水務署
Water Supplies Department

**Approval of "AXOR" Basin Mixer
(General Acceptance No. C20180391)**

Name of Manufacturer: Hansgrohe SE
Country of Origin: Germany
Brand: Axor
Details of Fitting: 3/8" Single lever basin mixer
Model: 38034
Body Markings: AXOR Uno
Expiry Date: 28 December 2022

38034

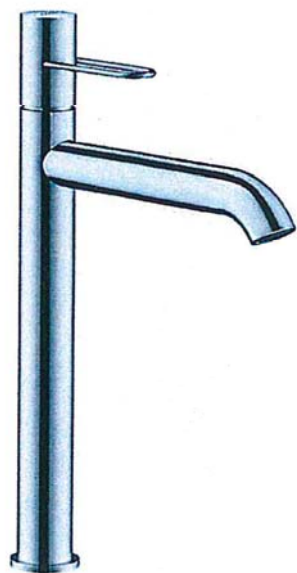
Having considered the test report ref. 171961ST170928(26) issued on 29 March 2018 by Fugro Technical Services Limited, this Authority accepts that the fitting described below complies with, and its use when correctly installed does not contravene, the Waterworks Ordinance and Regulations.

This Authority hereby permits the use of the above fitting in fresh water plumbing systems subject to full adherence to Waterworks installation requirements. In particular, you are required to draw your customers' attention to the following requirement-

"The cold water supply to the fitting shall be drawn from the same source that supplies the hot water apparatus so as to provide a balanced pressure and to obviate the risk of scalding in the event of a restriction or failure in the water supply."

A condition of this acceptance is that the fitting to be installed shall be replicas of the sample as certified by the testing agent mentioned above and without modifications. This acceptance may be withdrawn at any time if the standard of the fitting installed fails to meet that of the approved sample or if the fitting is found to be unsuitable for use in fresh water plumbing systems.

This acceptance is only applicable to the main body of the fitting, unless other specified.
